URGENT Field Safety Notice

DigitalDiagnost C50 System
Telescopic Carriage Balance Issue

27-Feb-2023

Appendix A Addendum to the Instructions for Use

Figure 1. Structure of telescopic carriage

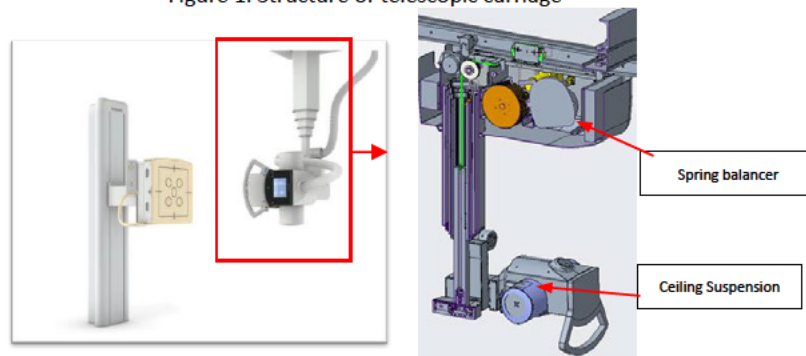
Philips has identified an issue that may occur with the DigitalDiagnost C50 system if Planned Maintenance (PM) is not completed as prescribed in the Instructions for Use (IFU). If the PM for the telescopic carriage is not performed annually as defined in the Instructions for Use (IFU), the tension force of the spring balancer inside of the telescopic carriage will unavoidably decay through normal wear and tear; as a result there is a potential that the Ceiling Suspension of the DigitalDiagnost C50 system may descend inadvertently if power to the system is interrupted, which may result in injuries to patients and users (Refer to figure 1).

- Follow the Planned Maintenance Program in the Addendum to the Instructions for Use in Appendix A of this notice for the safe use of your system(s).
- If the Ceiling Suspension is not able to be kept in its current position by itself and descends after the power to the system is off, contact your local Philips representative to perform the maintenance of the telescopic carriage.
- Place this *URGENT Field Safety Notice* with the documentation of your system(s).
- Complete the enclosed Customer Reply Form and send it back to confirm that users have reviewed and understood this *URGENT Field Safety Notice*.
